# Rezoning Application: RZ-PD 24-1013

Zoning Hearing Master Date: April 15, 2025

Development Services Department

The applicant is requesting to rezone 2.5+/- acres from AS-1 (Agricultural, Single-Family) to PD (Planned Development) to allow for a 13,000 square foot shopping and office center development with limited uses.

**2.4 Proposed Site Plan** (partial provided below for size and orientation purposes. See Section 8.0 for full site plan)

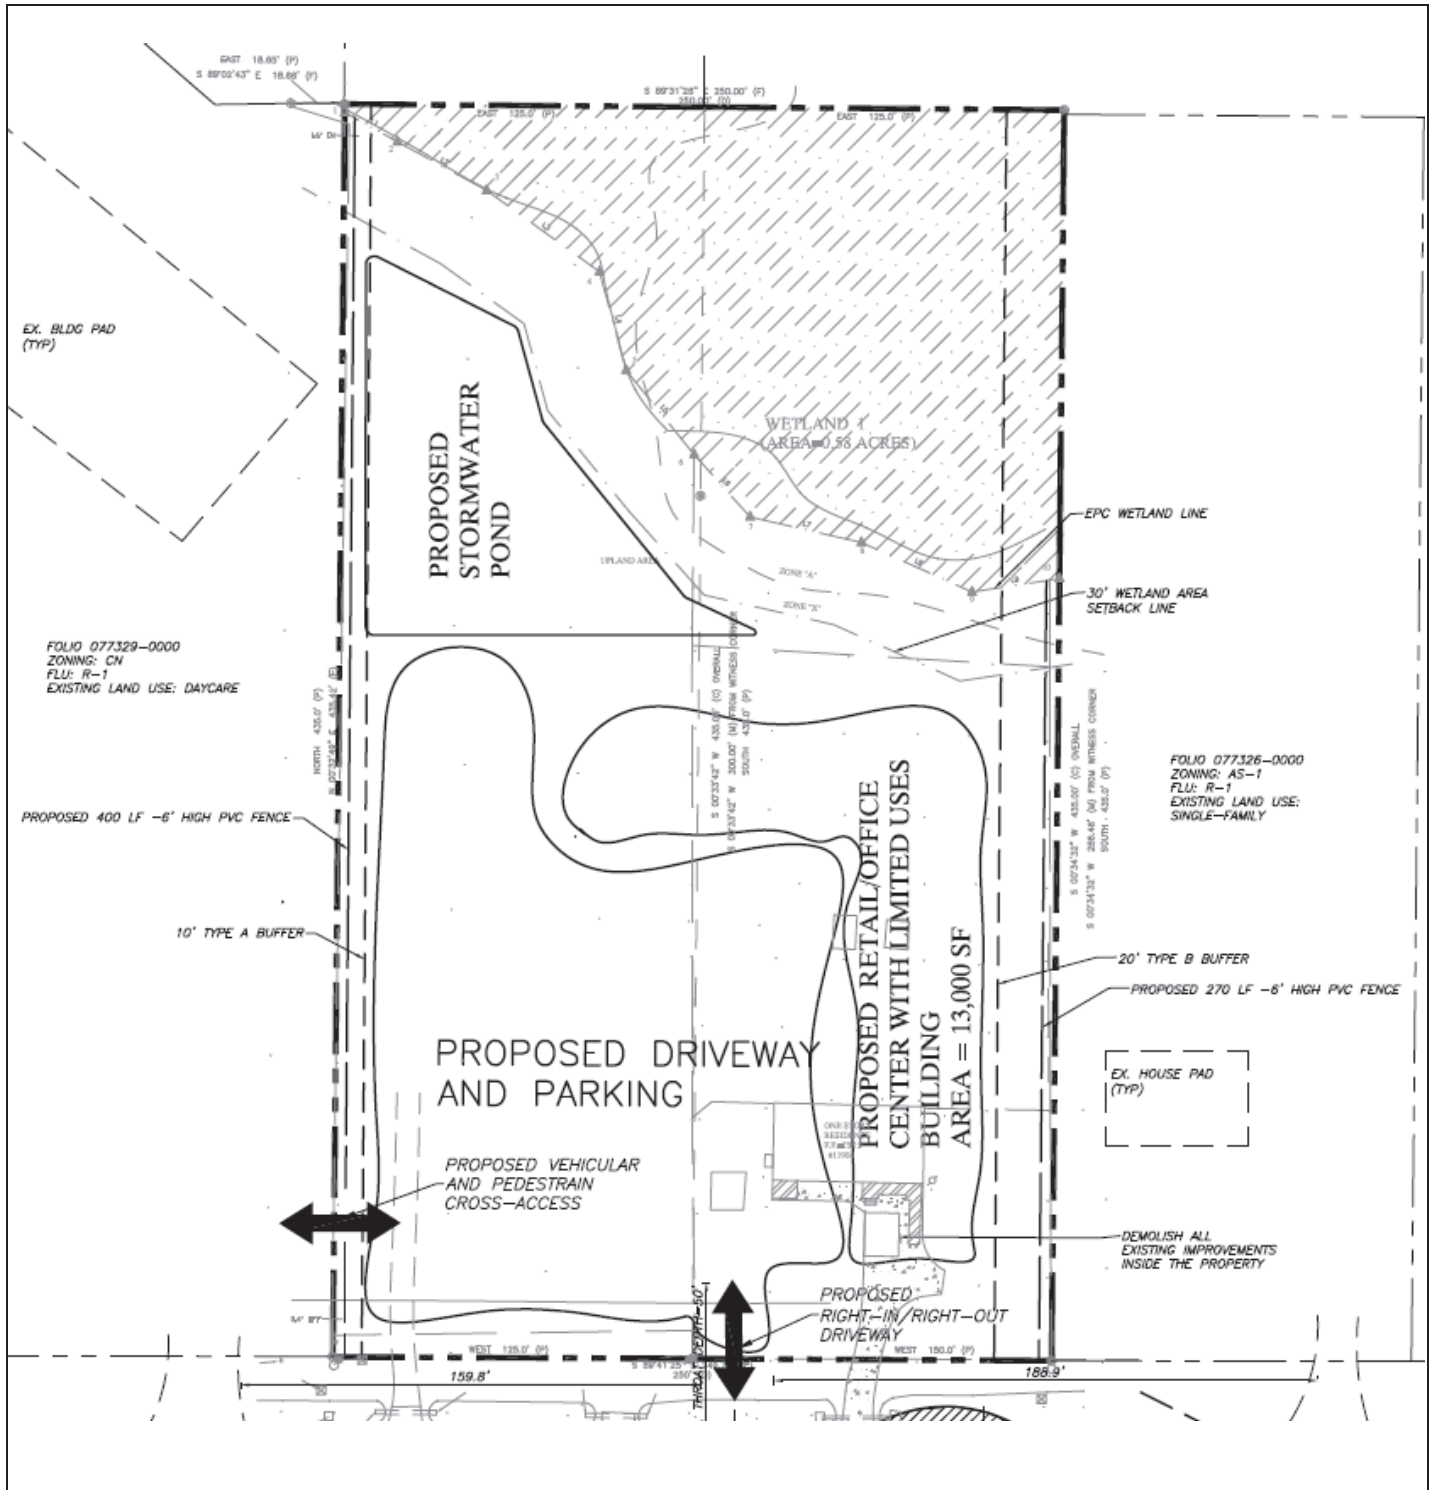
1. Please revise the general site plan to allow for a west side and rear yard setback that is reflected by the building bubble location.
2. Remove "CG Zoning District Standards" from Project Data Table.
3. Update Project Data Table and building envelope notation to list uses found in Condition 1.

- e. West Side Yard Setback Minimum: 10 feet
  - f. Front Yard Setback Minimum: 30 feet
  - g. Rear Yard Setback Minimum: 160 feet
4. Buffering and screening shall be provided shown on the General Site Plan:

SPACING EXHIBIT

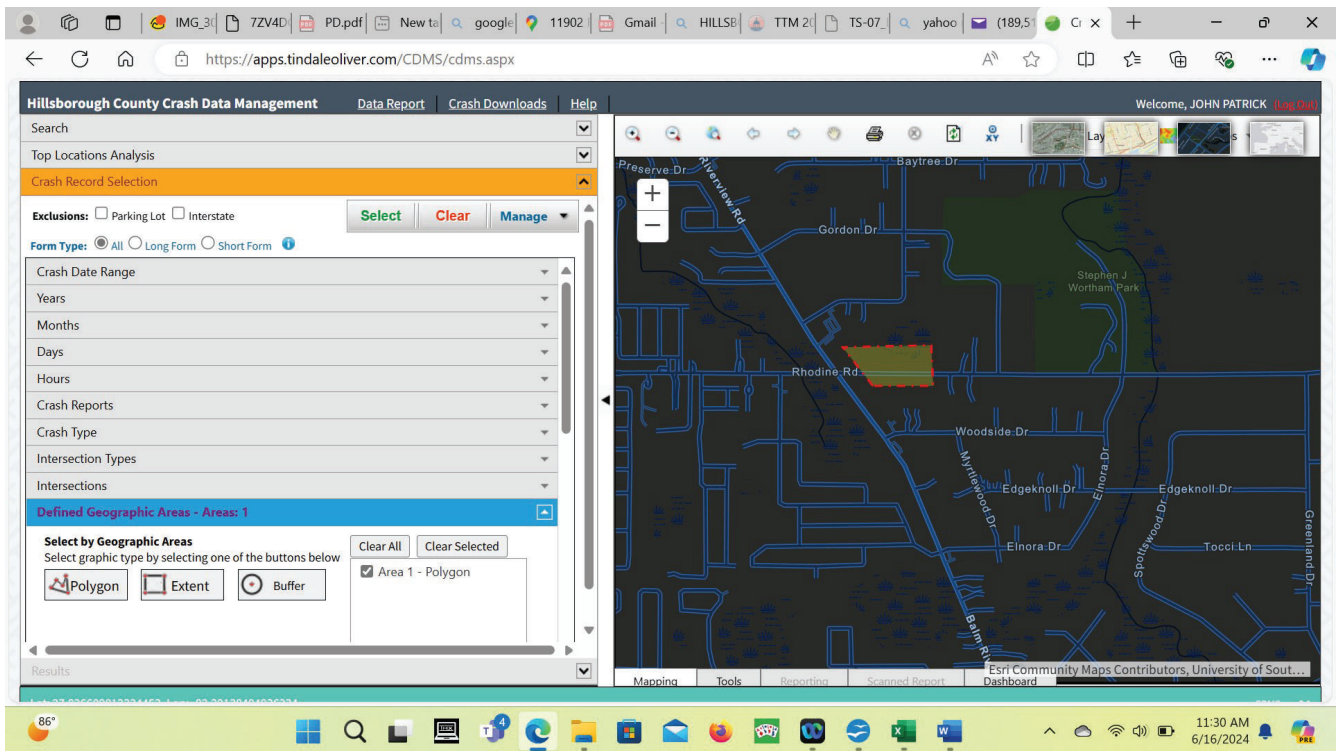
5. Description of what the LDC/zoning conditions requires: *Section 6.04.07 requires the proposed driveways to be 245 feet from other driveways. As the Site Plan shows, on Rhodine Road, the proposed driveway is 159 feet from the driveway to the west, and 183 feet from the driveway to the east, and does not meet required minimum driveway spacing in either direction. This request is not considering the spacing to the south side of Rhodine Road because this development is proposing a right-in/right-out access by the proposal of a traffic separator.*

Existing conditions – 3 approximately 10.25 foot lanes

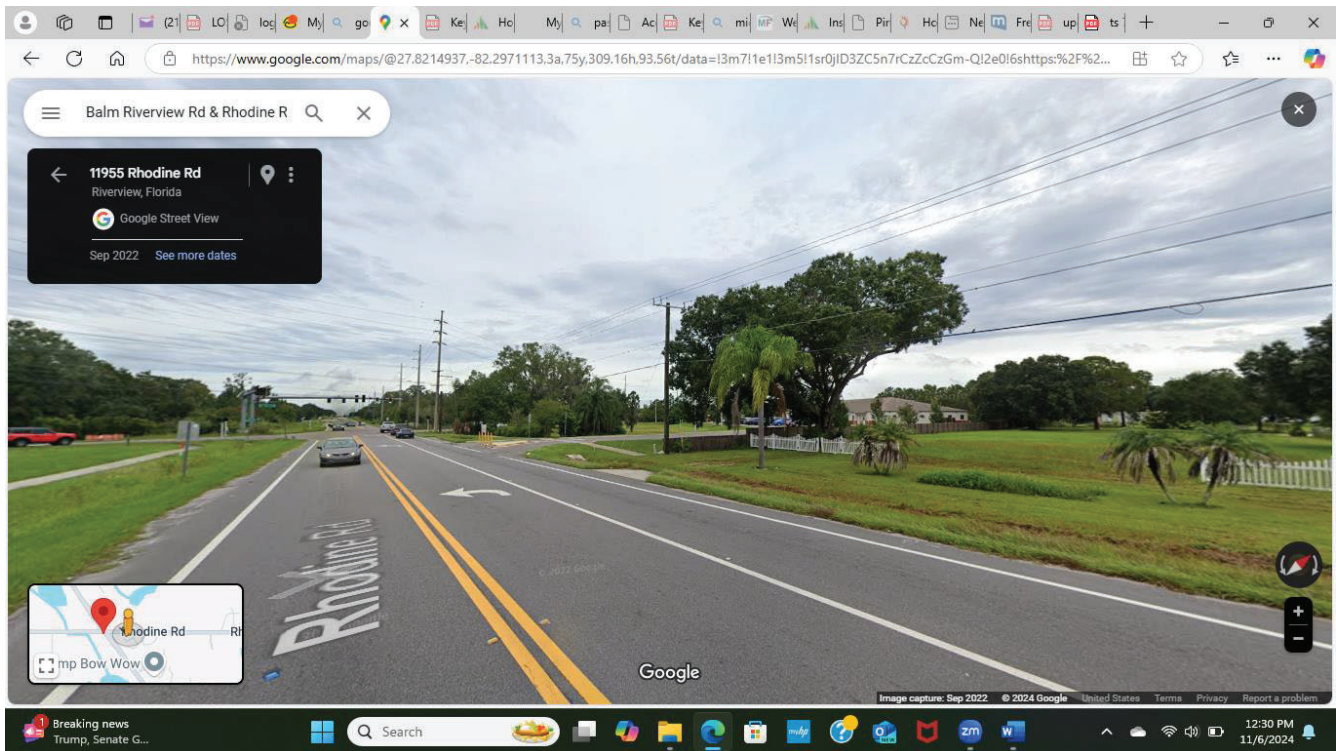
3. *JUSTIFICATION FOR THE REQUEST* - The 4 foot wide raised concrete median will keep traffic from turning left in or out of the site, and thereby reduce potentially conflicting

movements. There is a higher potential for conflict associated with left turns as compared with right turns. Constructing the separator will create a right-in/right-out driveway for the site thereby rendering the roadway more safe than if the separator were not to be constructed.
